**THE SCHOOL DISTRICT OF PHILADELPHIA
Office of Capital Programs
440 North Broad Street, 3rd Floor – Suite 371
Philadelphia, PA 19130**

Addendum No. 3

Subject: Delaplaine McDaniel Elementary School
2022 Classroom Modernization
SDP Contract Nos. 2022-009-G, 2022-009-E

This Addendum No. 3, dated FEBRUARY 18, 2022, shall modify and become part of the proposed Contract Documents of the work of this project. Any items not mentioned herein, or affected by, shall be performed strictly in accordance with the original Contract Documents, unless modified by prior addenda.

DRAWING NO.
ED101

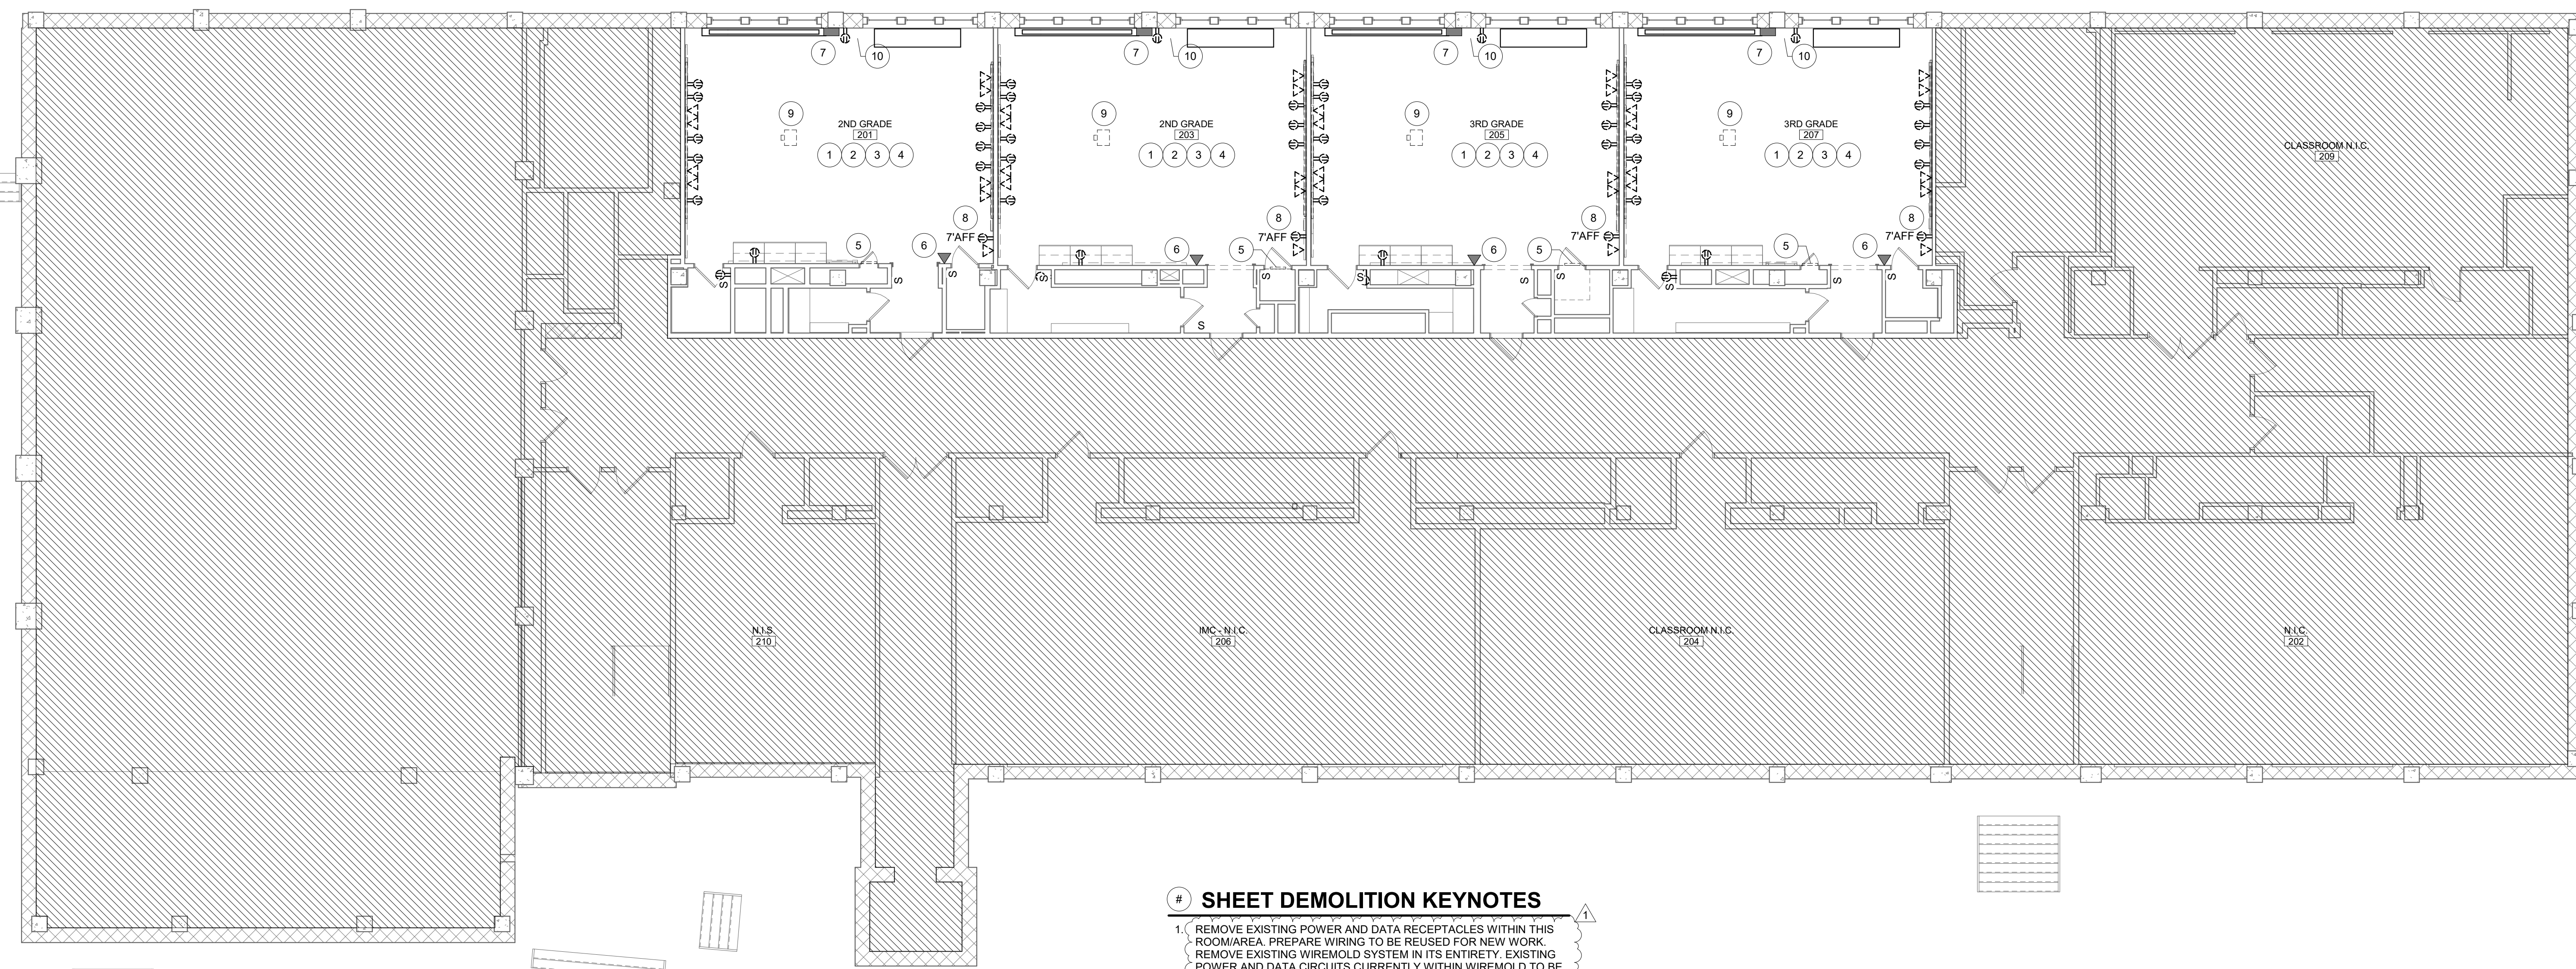
17. **Question:** Keynote 2 on drawing ED101/ED102 and keynote 3 on drawing E101E/102 state that all data/telephone/coaxial outlets within this room are to remain. However, these devices are shown with dashed lines in the demo plans, and bold lines in the new work plans, which indicates that we are to demolish and provide new devices. These dashed & bold lines conflict with the direction stated in the keynotes. Please clarify we are to provide new devices, and if we are to provide new CAT6.

18. **Response: Refer to keynote 1 on revised ED101 and ED102 and keynote 3 on revised E101 and E102 attached.**

DRAWING NO. ED201

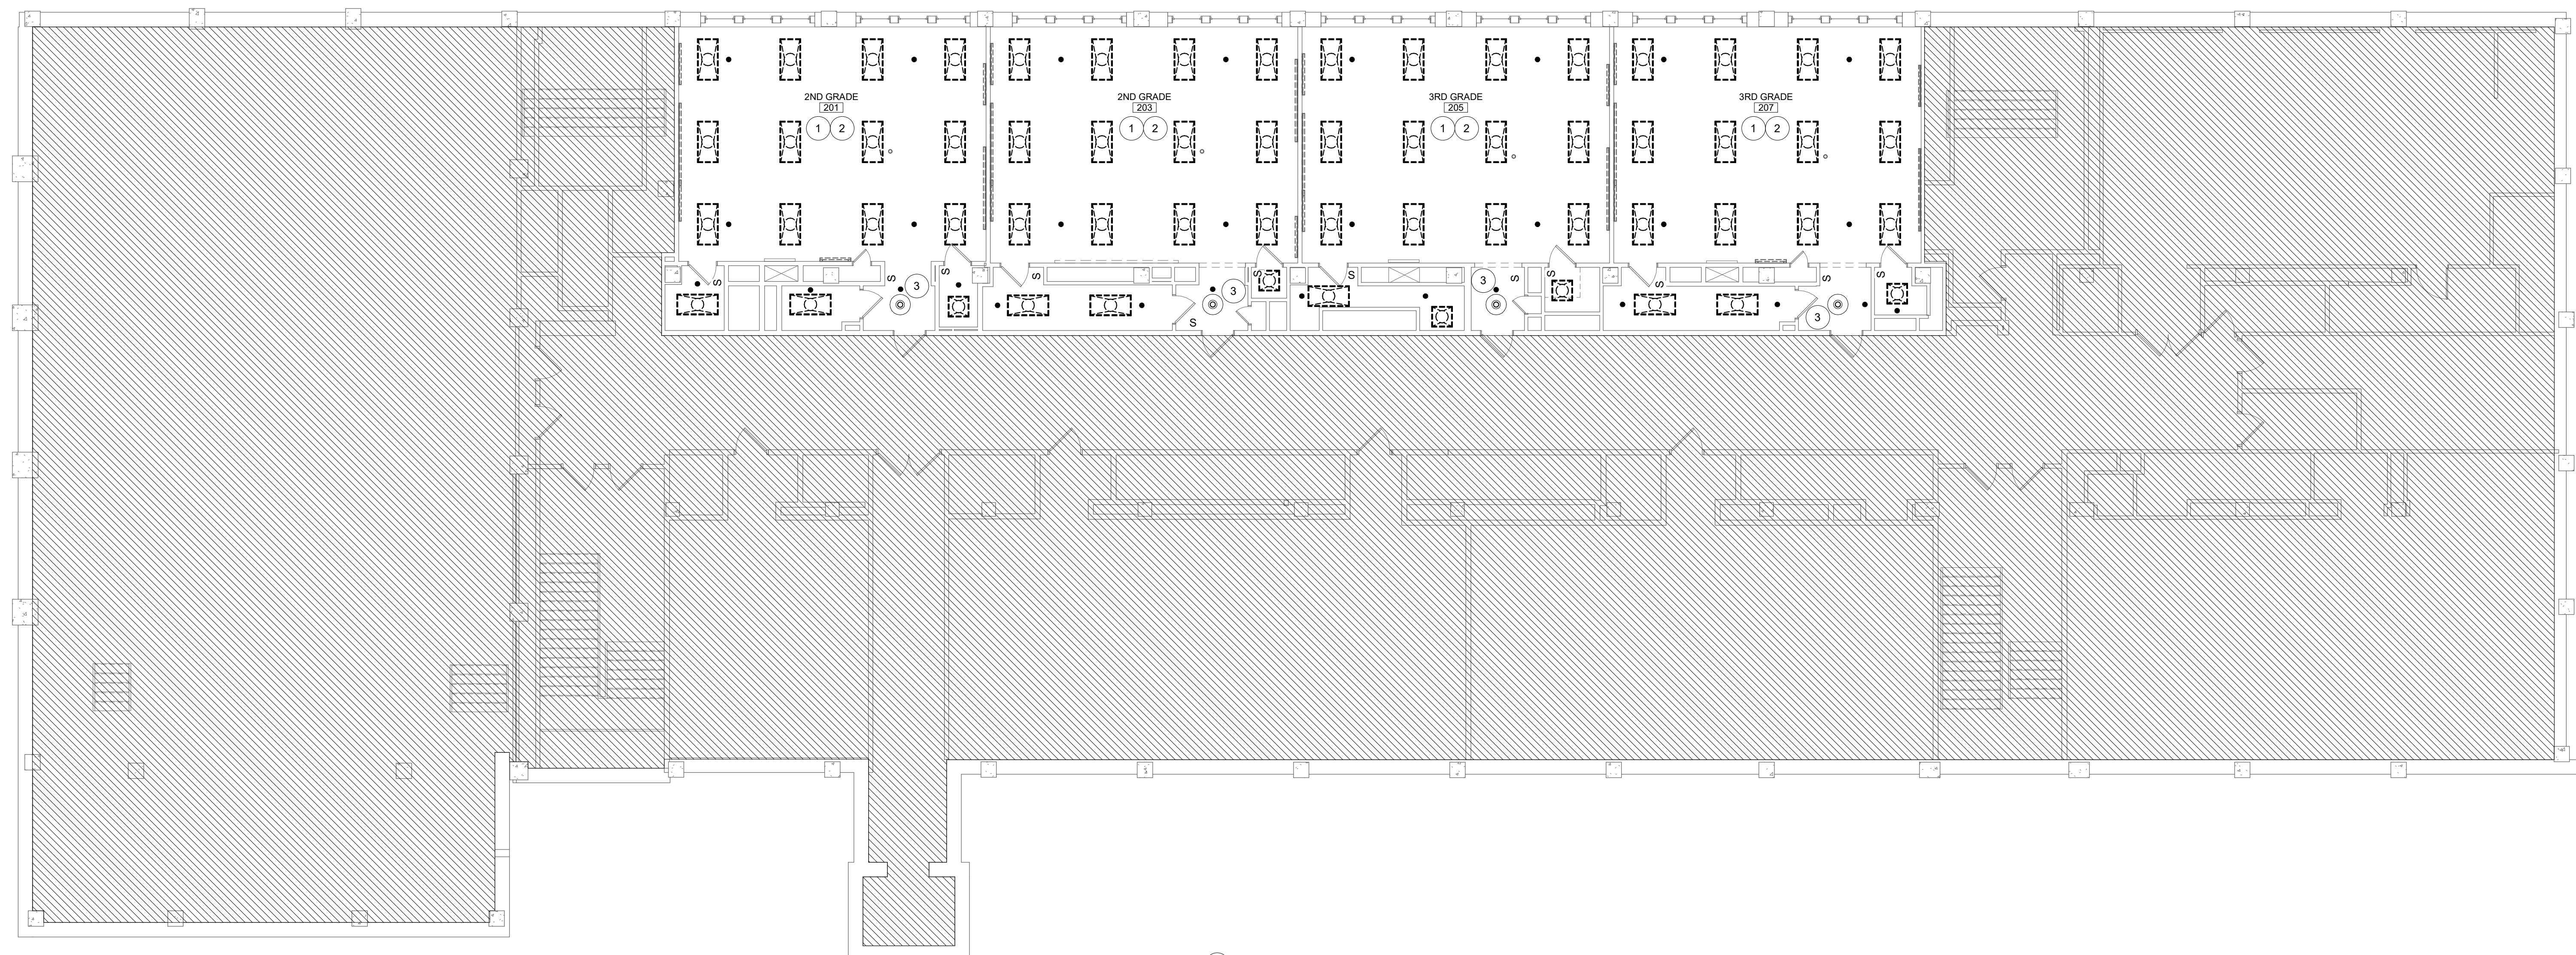
20. **Question:** Keynote 2 on ED201/ED202 states to provide new ceiling tiles as needed to accept new lighting layout. Please confirm new ceiling tiles are to be provided by the GC contract.

Response: Refer to keynote 2 on revised ED201 and ED202 attached.

DRAWING NO.
E101

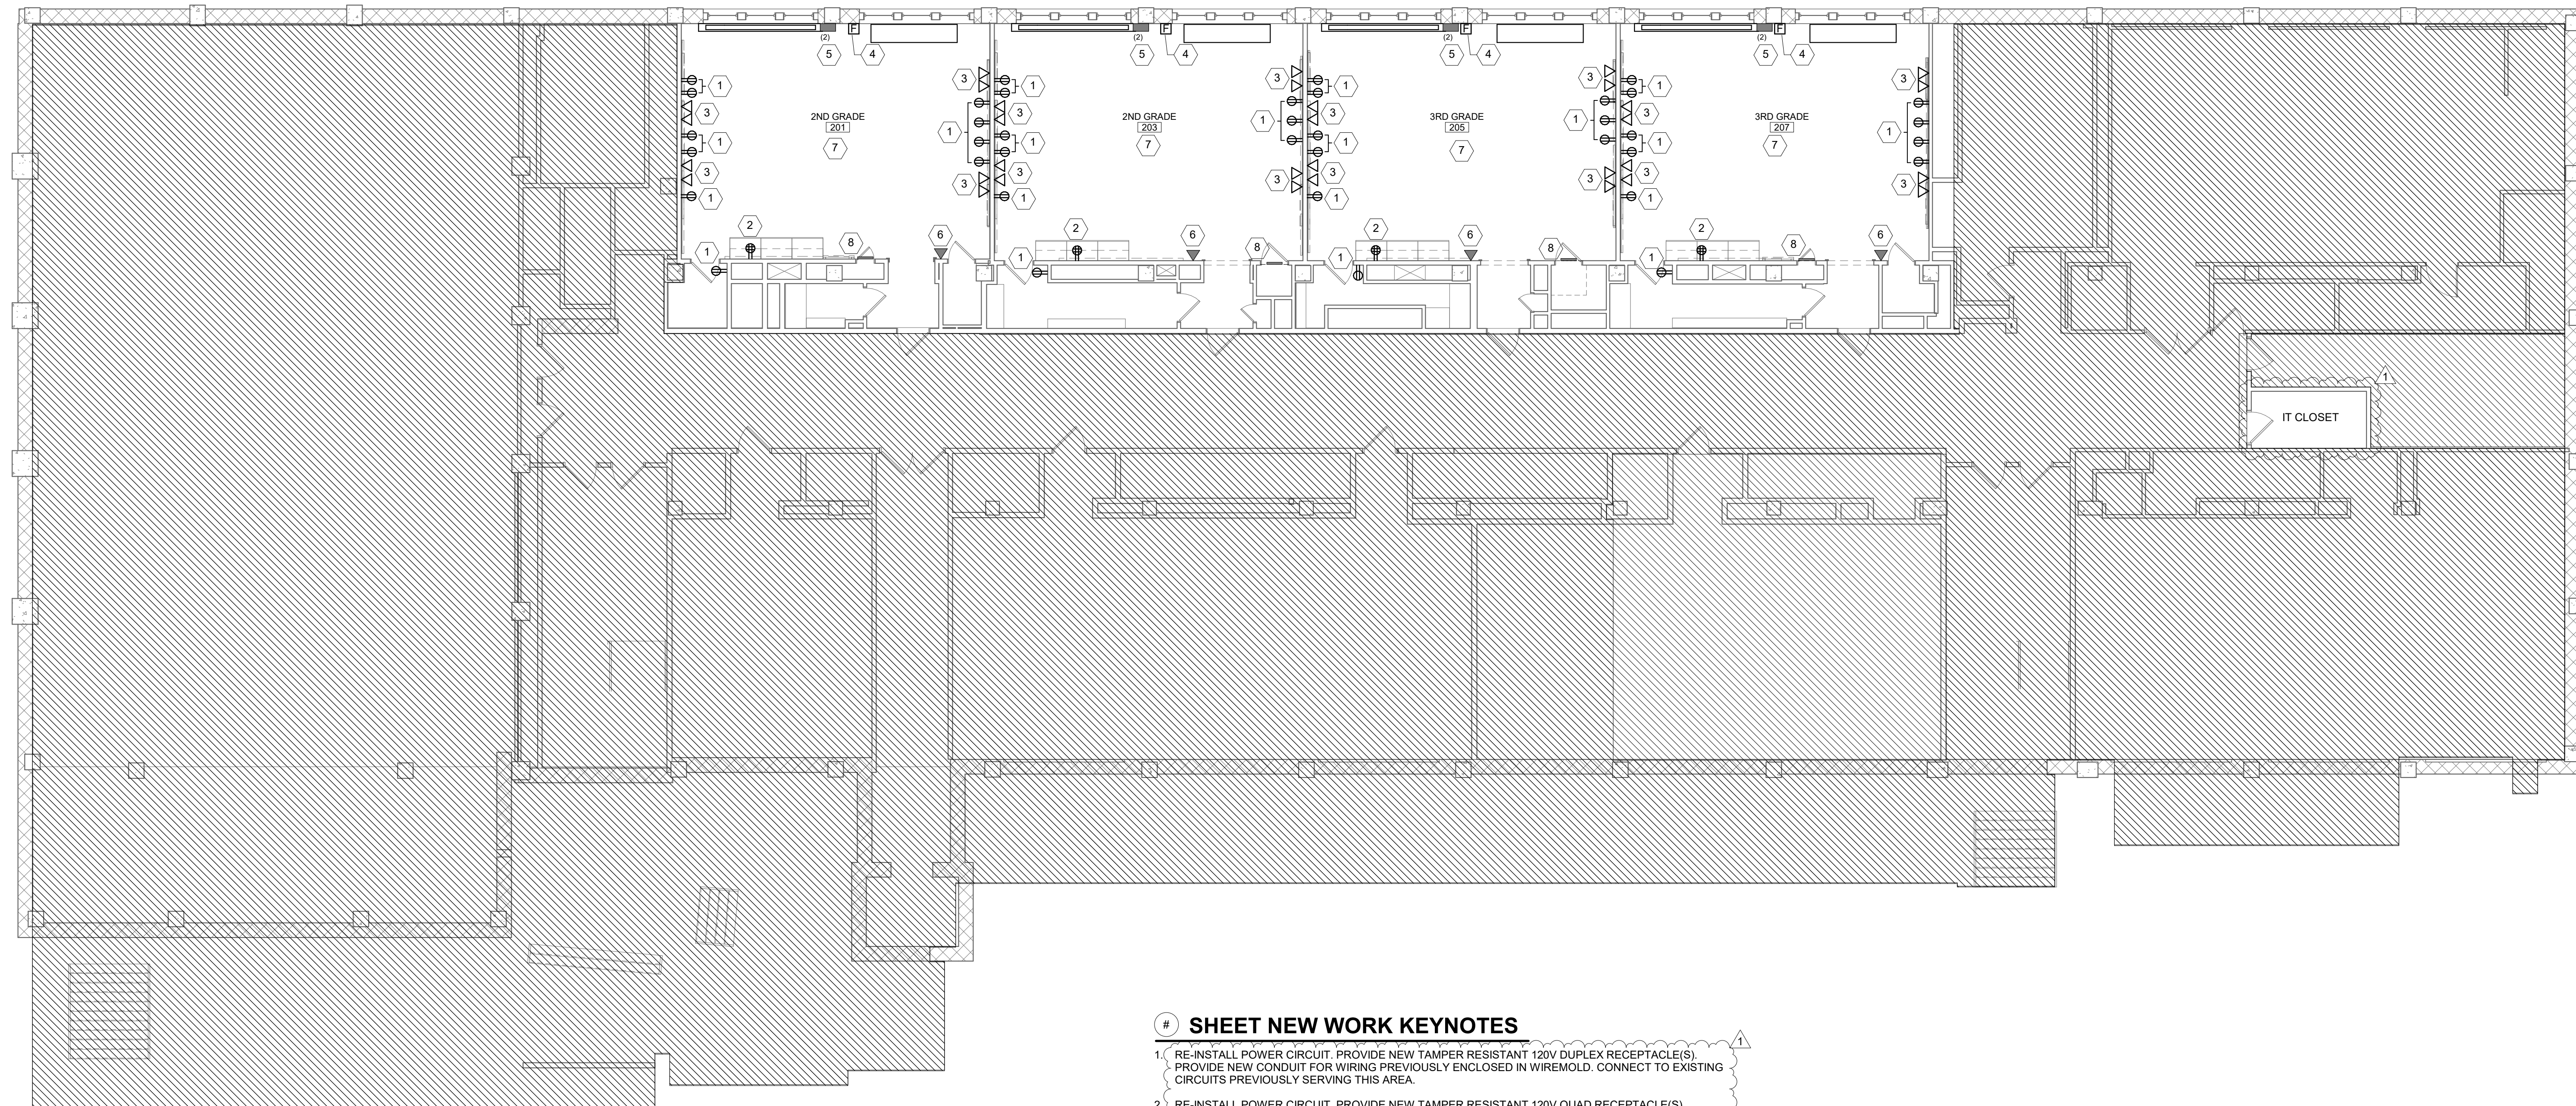
5. **Question:** Ref: Drawings E100, E101, E102, E103 SHEET KEYNOTE #3 - How do we bid "Provide new data outlets & Cat 6 cabling as needed"?

6. **Question:** Ref: Drawings E100, E101, E102, E103 SHEET KEYNOTE #3 - Does each classroom have the Cat 6 cabling required for the quantity of drops?

7. **Question:** Ref: Drawings E100, E101, E102, E103 SHEET KEYNOTE #3 - What is the location in the buildings for the MDF?

9. **Question:** Ref: Drawings E100, E101, E102, E103 SHEET KEYNOTE #7 - "Provide new clock if existing is in working condition." Should we bid to replace clock only if it is in working condition?

10. **Question:** Ref: Drawings E100, E101, E102, E103 SHEET KEYNOTE #7 - What type clock (battery, 120 volt, 24 volt) & quantity should we bid to replace? Are you requiring a systems clock (Sapling) or an off the shelf unit?

16. **Question:** Division 27 specs were not provided. Please confirm CAT6 cable should be provided for new voice drops, new data drops, and new WAP drops. Please confirm CAT6 should be run on j-hooks above drop ceilings, and in EMT when exposed.

Response: Refer to sheet keynote 3 on revised E101 and E102 attached.

Response: Refer to sheet keynote 3 on revised E101 and E102 attached.

Response: Refer to locations shown on revised E101 and E102 attached.

Response: Provide new clock - refer to keynote 8 on revised E101 and E102 attached.

Response: Clocks are to be Sapling, hardwired. Refer to specification section 275313 attached.

Response: Existing wiring to be reused in new conduit and outlets. Refer to keynotes 1, 2, 3 on revised E101 and E102 attached. Provide CAT6 for all new work, refer to spec section 271300 Communications Systems attached.
